**MONTGOMERY COUNTY HISTORIC PRESERVATION COMMISSION**  
**STAFF REPORT**

<b>Address:</b>	7006 Carroll Avenue, Takoma Park	<b>Meeting Date:</b>	1/10/2024
<b>Resource:</b>	Contributing Resource <b>Takoma Park Historic District</b>	<b>Report Date:</b>	1/3/2024
<b>Applicant:</b>	Kathleen & John Stone	<b>Public Notice:</b>	12/27/2023
<b>Review:</b>	HAWP	<b>Tax Credit:</b>	Partial
<b>Permit Number:</b>	1052543	<b>Staff:</b>	Dan Bruechert
<b>Proposal:</b>	Comprehensive façade alterations including lighting and awning signage

# PROPOSED STOREFRONT

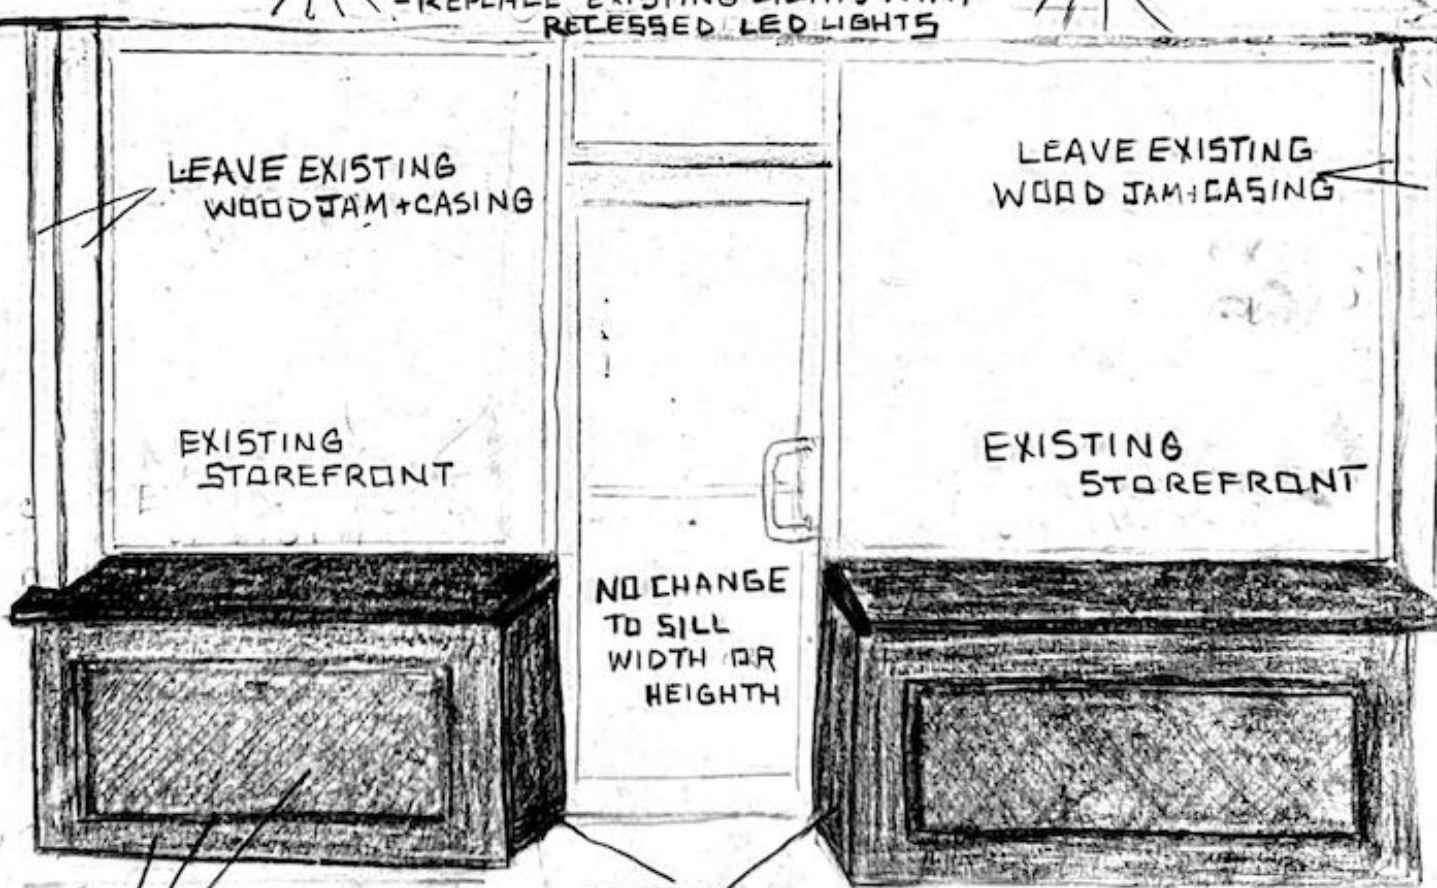
LEAVE EXISTING OVERHANG + SIGNAGE

- REPLACE EXISTING VINYL SOFFIT MATERIAL  
- REPLACE EXISTING LIGHTS WITH  
RECESSED LED LIGHTS

LEAVE EXISTING  
WOOD JAM + CASING

LEAVE EXISTING  
WOOD JAM + CASING

7006 CARROLL AVE  
STOREFRONT

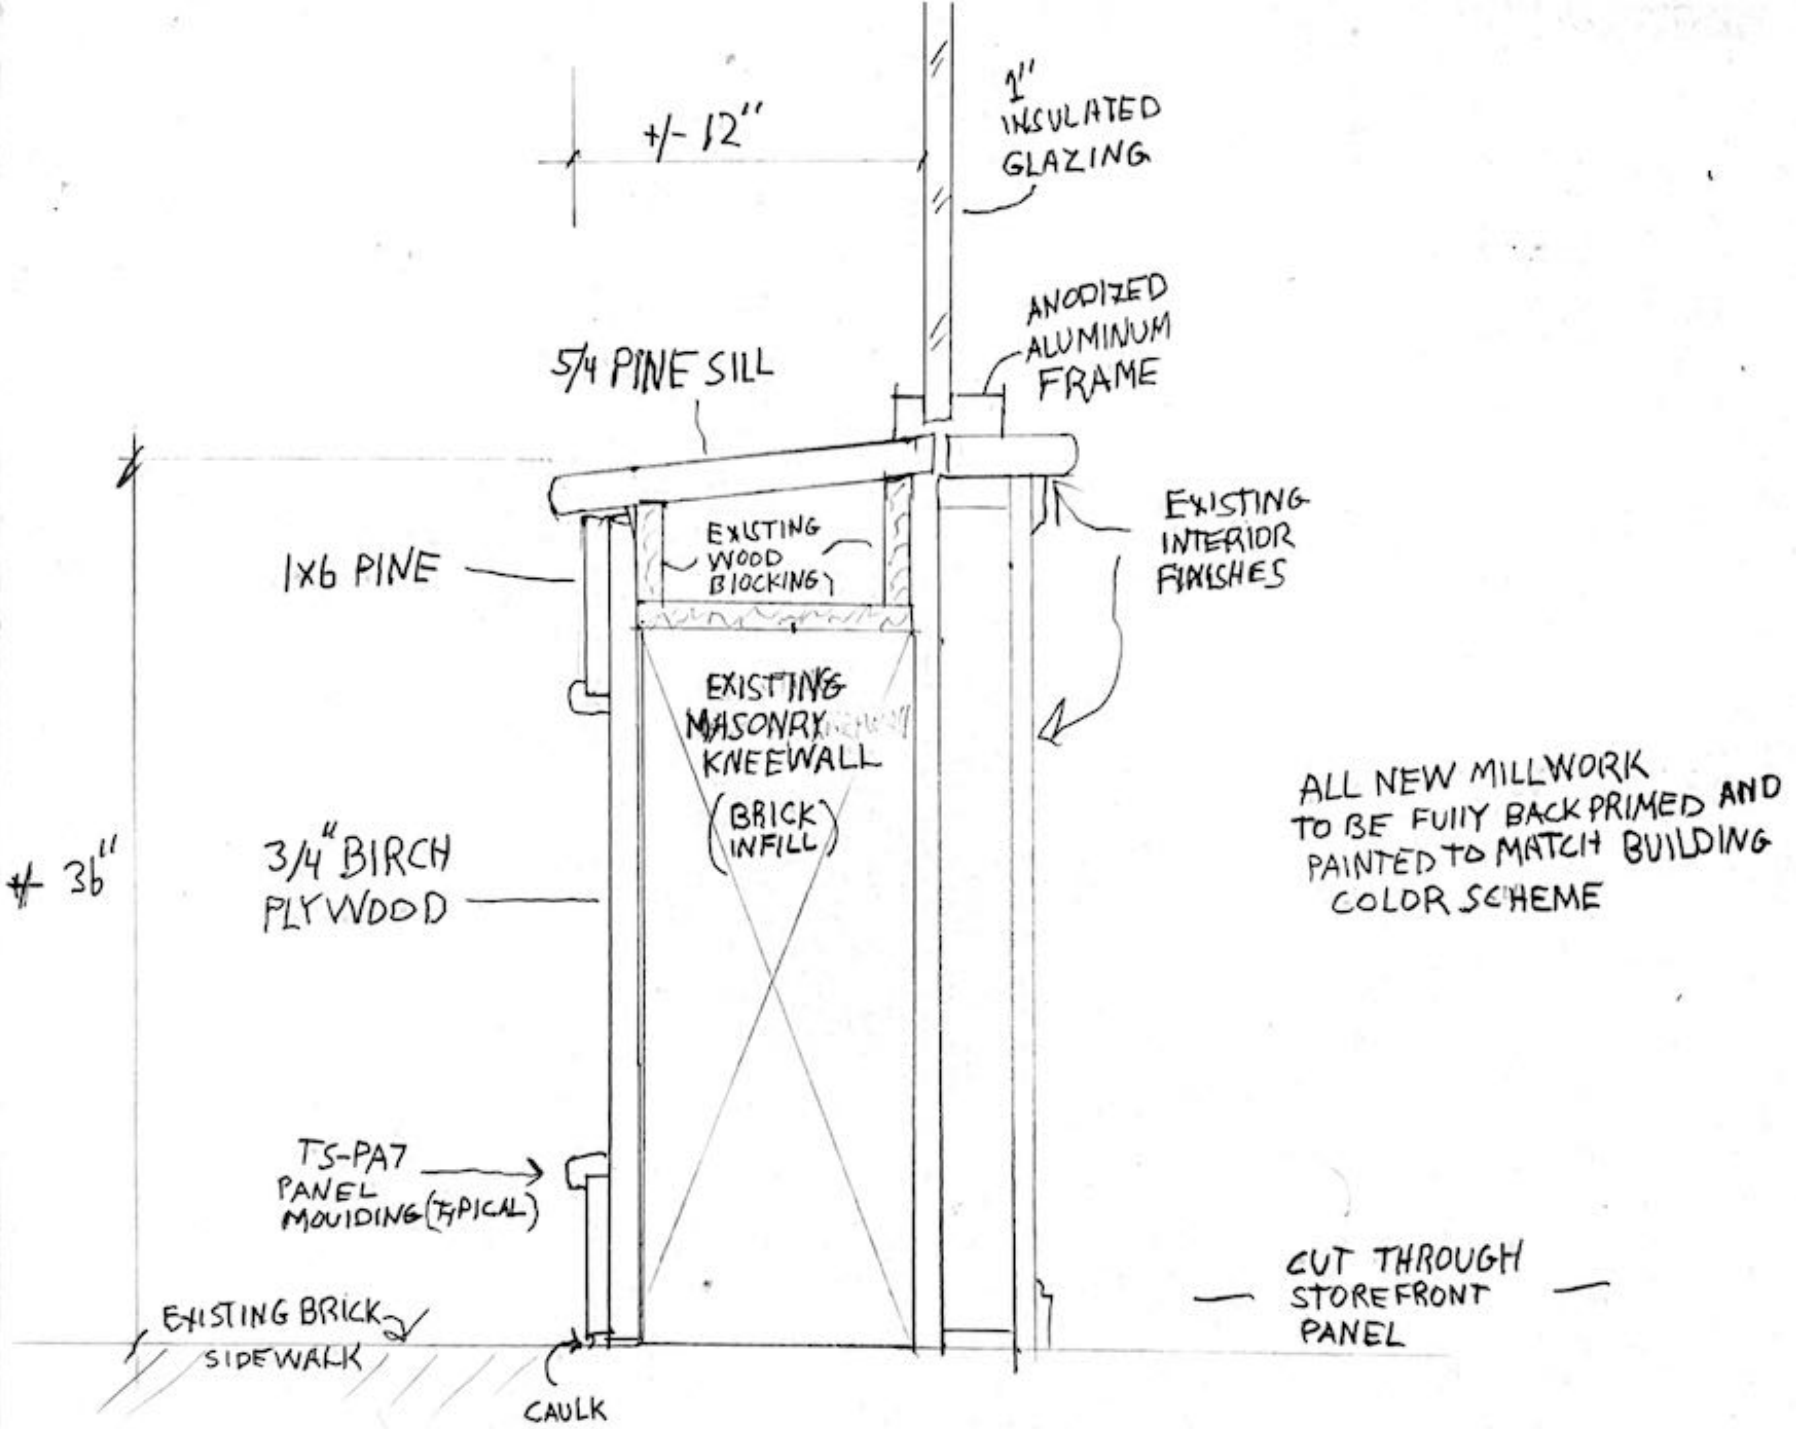
NO CHANGE  
TO SILL  
WIDTH OR  
HEIGHT

3/4" FLAT PRIMED PINE PANEL  
TO COVER FILL BRICK

3 PIECE WOOD PANEL - PRIMED PINE FLAT STOCK

3/4" FLAT WOOD PANEL  
TOPPED WITH 5/2" BAND OF 3/4" WOOD  
FINISHED WITH BAND OF COVE MOLD  
AS SHOWN
